Staff Report

Agenda Item: Variance Request 13532 Valley Vista Drive Building B

Project Description: Variances to regulations of the Unified Development Code pertaining to Master UDC Section 3.5.3.12- Storefront Code; Transparency.

BUILDING B - TRANSPARENCY EXHIBIT

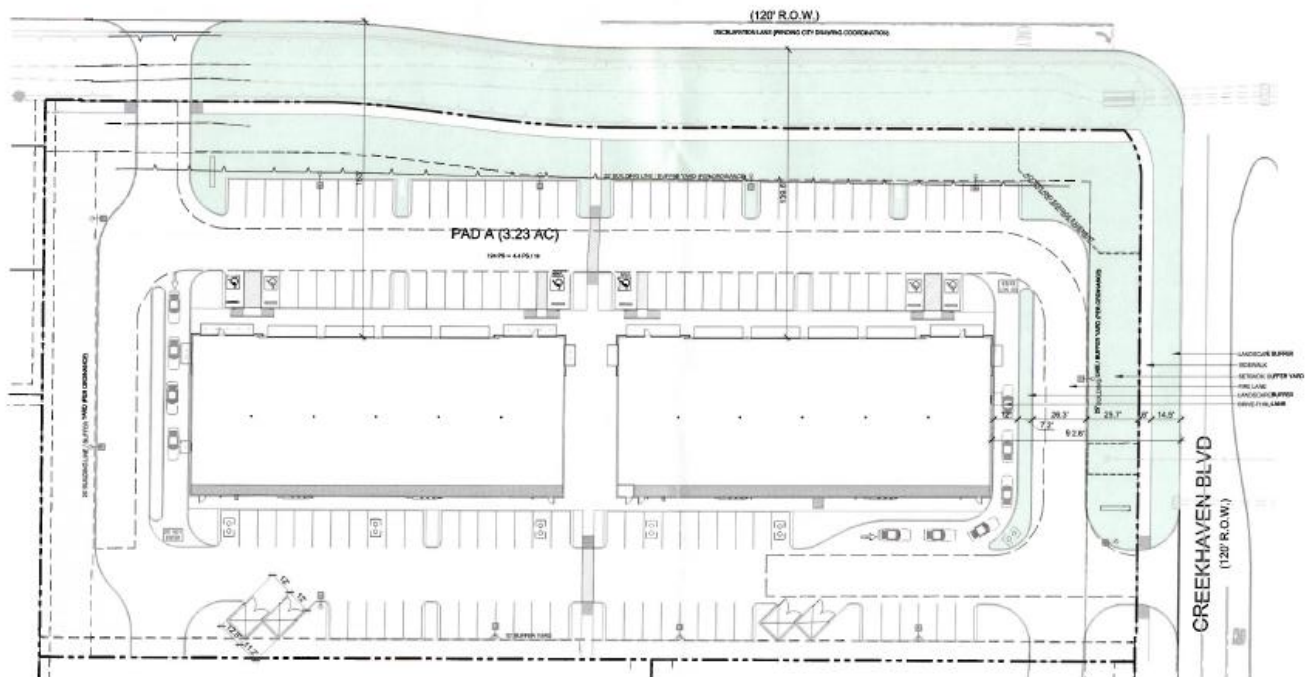
In regards to the variance request at 13532 Valley Vista Road - Building B , we are requesting to have the transparency requirement of sixty-five (65%) as required by the UDC Section 3.5.3.12 Storefronts reduced to from sixty-five (65%) to fifty - three (53%).

Exterior Wall Area: 79 LF
Transparency Required: 65% = 51 LF
Transparency Provided: 53% = 42 LF

- Windstorm area
- Cost associated with additional glazing, steel and material to meet the requirement.
- Kitchen behind glass

The purpose of this code is to ensure the security and welfare of the occupants which could be monitored from the street or right of way. Staff recommends that there be some type of transparency to the Southside of the building to meet the intent of the Unified Development Code.
